SUBJECT: DRESDEN NUCLEAR POWER STATION, UNITS 2 AND 3 – STAFF  
ASSESSMENT OF RESPONSE TO 10 CFR 50.54(f) INFORMATION  
REQUEST – FLOOD-CAUSING MECHANISM REEVALUATION (TAC  
NOS. MF1795 AND MF1796)

STAFF ASSESSMENT BY THE OFFICE OF NUCLEAR REACTOR REGULATION  
RELATED TO FLOODING HAZARD REEVALUATION REPORT  
NEAR-TERM TASK FORCE RECOMMENDATION 2.1  
RELATED TO THE FUKUSHIMA DAI-ICHI NUCLEAR POWER PLANT ACCIDENT  
DRESDEN NUCLEAR POWER STATION, UNITS 2 AND 3  
DOCKET NOS. 50-237 AND 50-249

**Figure 3.2.6-1 Locations of Critical Doors and Bays**

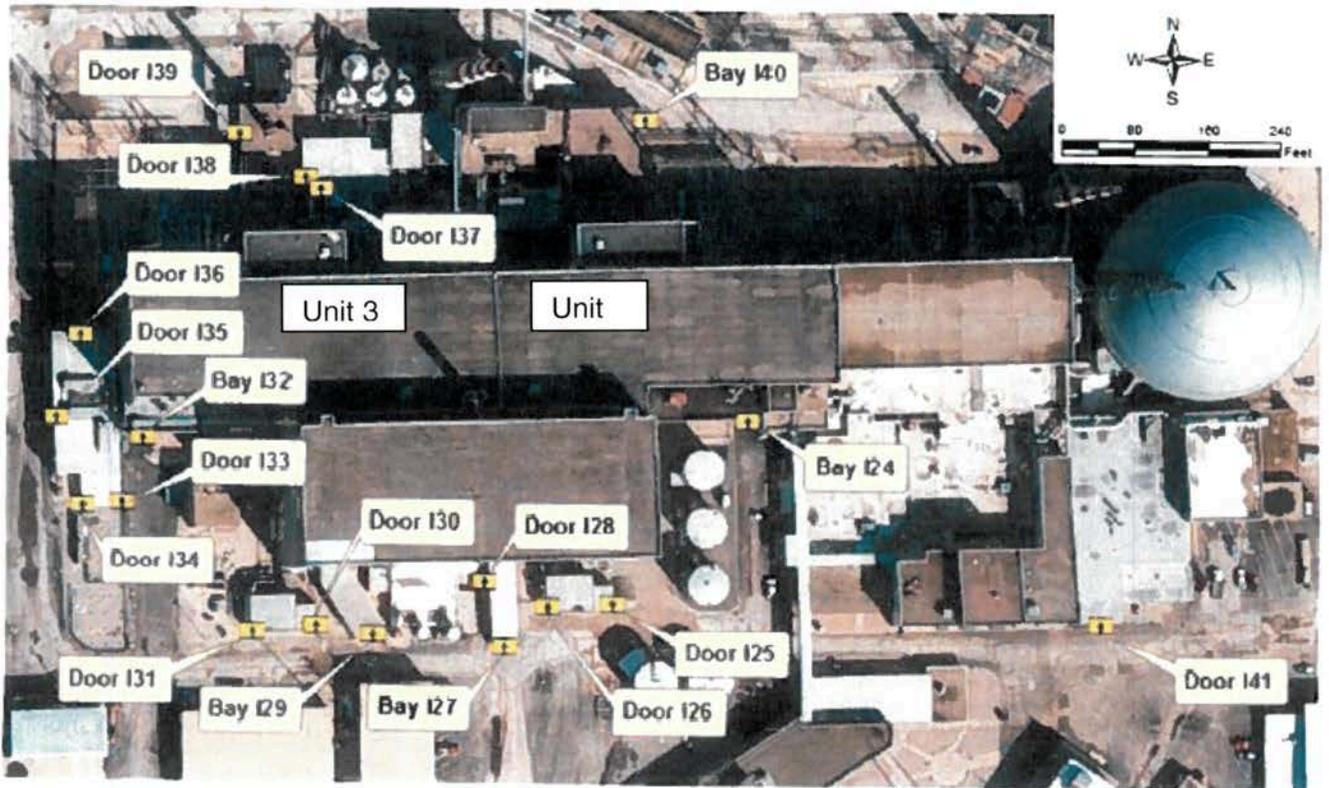
The staff noted that the site-specific PMP reduced the depth at critical doors and bays by a maximum of 0.2 ft (0.06 m) at Bay 124. The staff considered the difference in effective in flood depths between the site-specific PMP and the HMR-based PMP water depths to be small. For comparison, the typical height of a sandbag is 0.3 ft (0.1 m) (see *Sandbagging Techniques* (USACE-NWD, 2004)). Therefore, the staff did not review site-specific PMP methodology associated with the RAI response since the revised rainfall (model input) effectively produces the same water depths (model output) at the site.
